# City of Phoenix

## ADDENDUM A

### Staff Report Z-42-23-7

\*REVISED November 1, 2023

PRELIMINARY  
 OVERALL SITE PLAN  
 SDI.11  
 date: 10-31-2023  
 job no: 2023.118  
 log no:

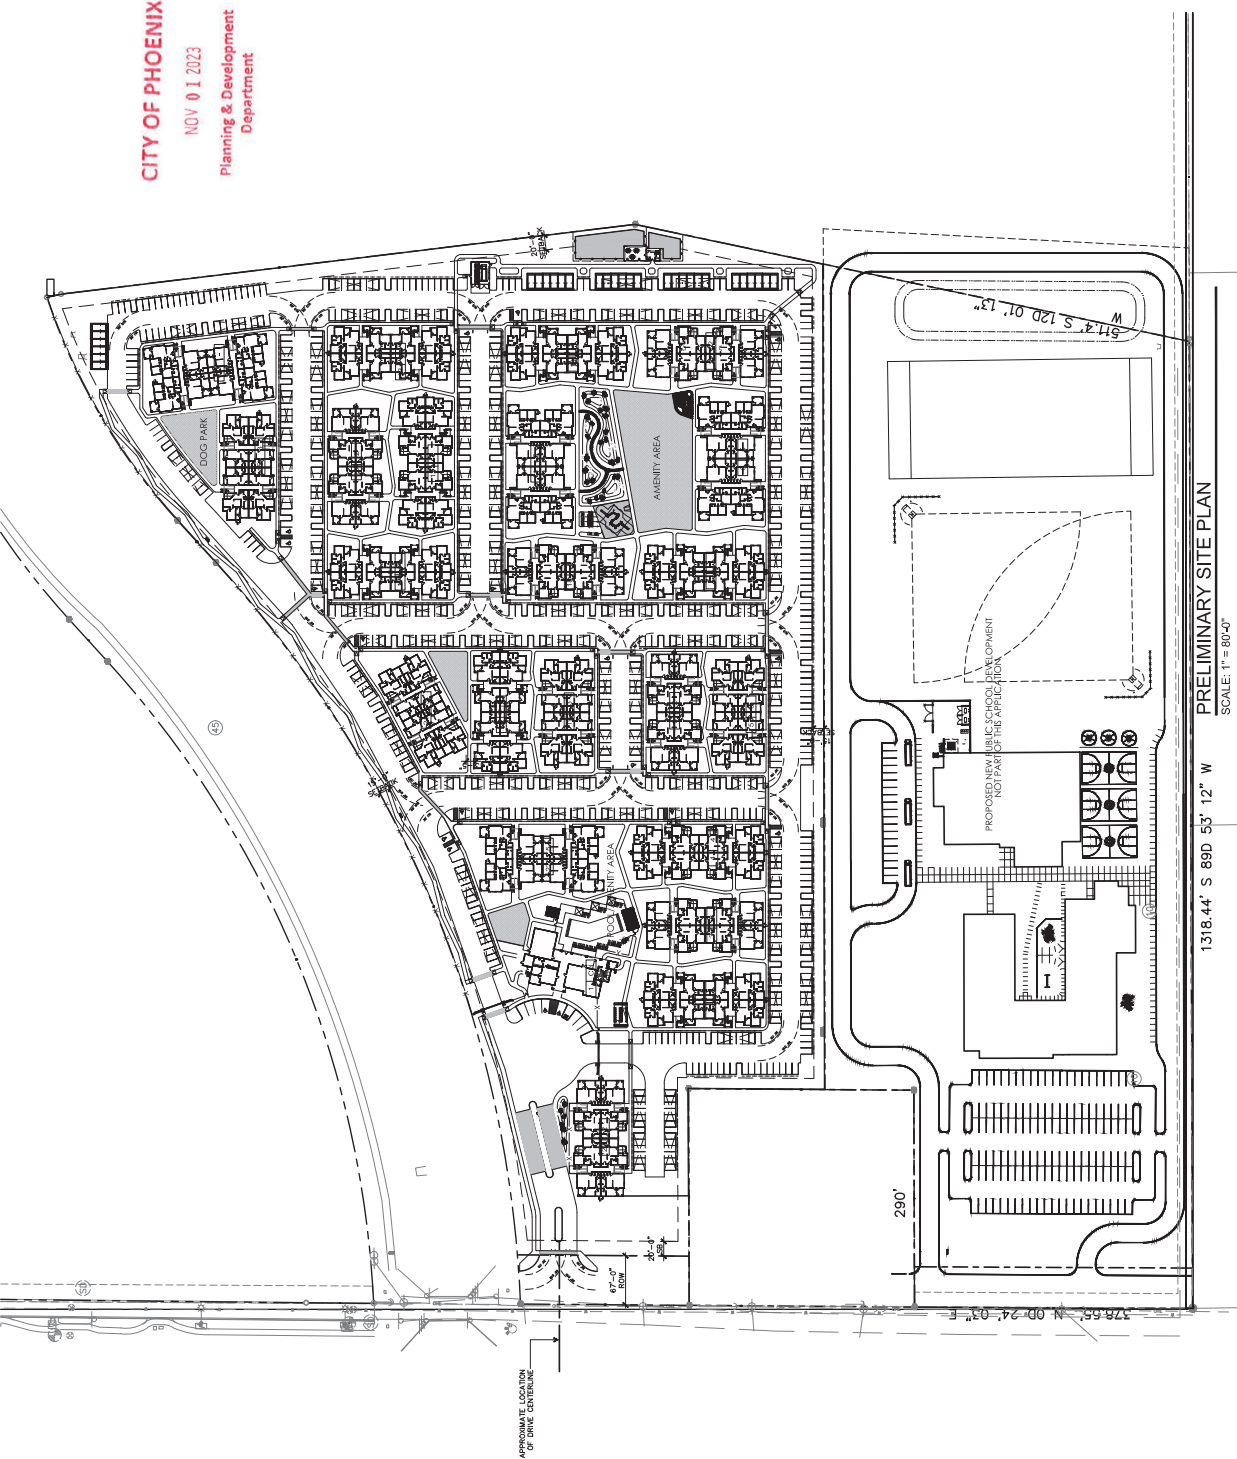
On October 16, 2023 the Laveen Village Planning Committee (VPC) heard this request and recommended approval, per the staff recommendation with modifications and additional stipulations. Stipulation No. 3 was added to require general conformance to the revised site plan to be submitted by the applicant after the \*meeting. The applicant has since submitted a revised site plan on November 1, 2023 that meets the required building setbacks when adjacent to the Loop 202 Freeway.

- \*3. THE MULTIFAMILY DEVELOPMENT SHALL BE IN GENERAL CONFORMANCE ~~TO THE FUTURE SITE PLAN SUBMITTED BY THE APPLICANT~~ WITH THE SITE PLAN DATE STAMPED NOVEMBER 1, 2023, AS MODIFIED BY THE FOLLOWING STIPULATIONS AND APPROVED BY THE PLANNING AND DEVELOPMENT DEPARTMENT.**

\*Revised Conceptual Site Plan date stamped November 1, 2023
